As a result of my inspection and meeting with you at your home on October 19th, the following report documents my comments and observations about the metal roof installation performed by XX Roofing, Inc. (XXX). Also in attendance was the installation manager for XX Roofing, Mr. XX and Mr. XX a representative from XX Building Supply (XXX), the metal roof material manufacturer.

LACK OF WEATHERTIGHTNESS

Photo #5

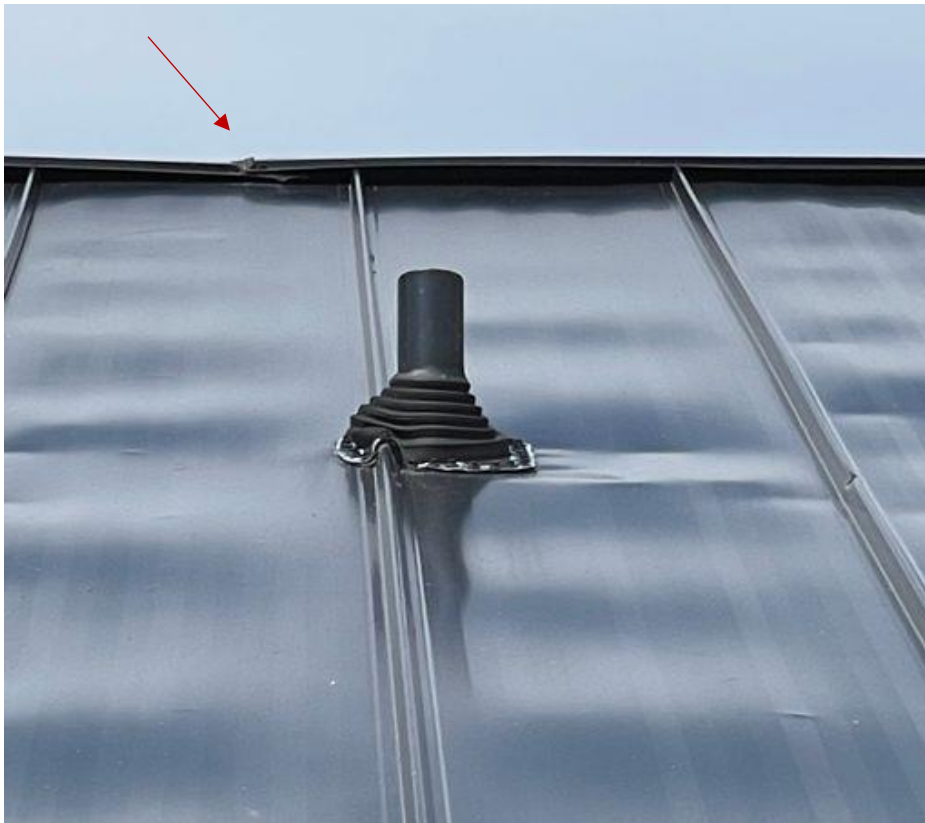
The ridge overlap conditions were not installed properly as shown with significant distortion and exorbitant use of caulking to fill large gaps. **photo #5** The end of the ridge line above the main entry has a patched small piece of gable under the ridge end that is unsightly. See **photo 6**. Large sections were used elsewhere as should have been the case here as well.

Photo #9

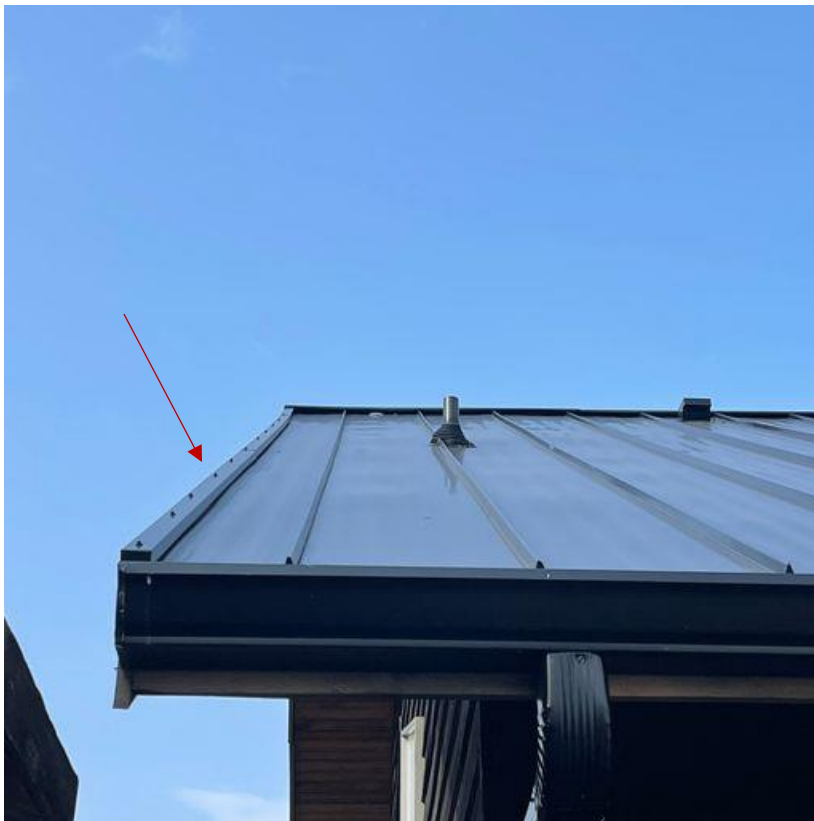
There are a number of problems with the gable/rake flashing details. **Photos 7 & 8** illustrate the improper overlap with significant gaps and lack of hem modification to allow a proper overlap. **Photos 9 & 10** show different gable on each side of the roof slope. The left gable has exposed fasteners and the right side does not. Both gables are different and the right side gable is not a manufacturers detail and is not installed in accordance with manufacturer standards. Notice the top fasteners on the gable in **photo 10**. The inconsistent gable flashings, lack of proper overlaps, excessive use of caulking to overcome poor craftsmanship and lack of following the manufacturers details suggest all gable flashings should be replaced and installed appropriately. The gable attachments may also contribute to the significant soffit staining and damage. See additional comments and photos in the “soffit” section later in the report.
